GOVERNMENT OF THE DISTRICT OF COLUMBIA
DEPARTMENT OF TRANSPORTATION

MEMORANDUM

SUBJECT: **BZA Case No. 19140** – 412 V Street, NE

Figure 1. Proposed Site Plan (Source: Applicant)

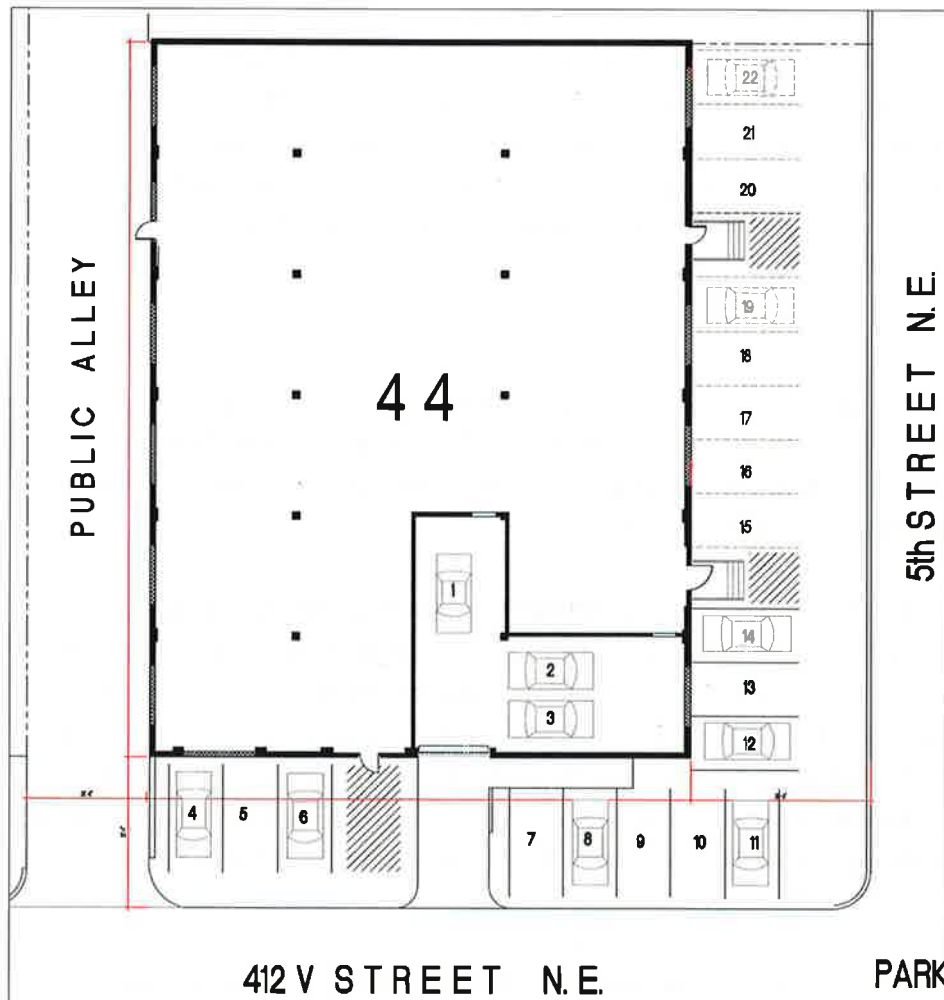
The Applicant proposes three off-street parking spaces through a curb cut on V Street and an additional 19 parking spaces in public space on V Street and 5th Street (see Figure 1), accessed either by extending the curb cut or driving over the curb.

In correspondence, the Applicant noted two small curb cuts to now bricked up garage doors; those curb cuts initially granted loading access into the building where there was a parking space, not to the entirety of the public space. When the private parking spaces or loading facilities ceased to exist, those curb cuts expired and ought to have been closed with a curb and gutter. A public space permit is required for a curb cut to access those three spaces since the existing curb cut is expired. Even if the Applicant intends to renovate the site so that garage access exists off of V Street, DDOT would not support access to the proposed three off-street parking spaces because vehicular access should be from the public alley.

The Applicant must apply for a permit for parking in public space, which will require approval by the Public Space Committee (PSC). DDOT does not support parking in public space. While parking in public space may have existed at the site during its previous use, these were not likely legal uses.
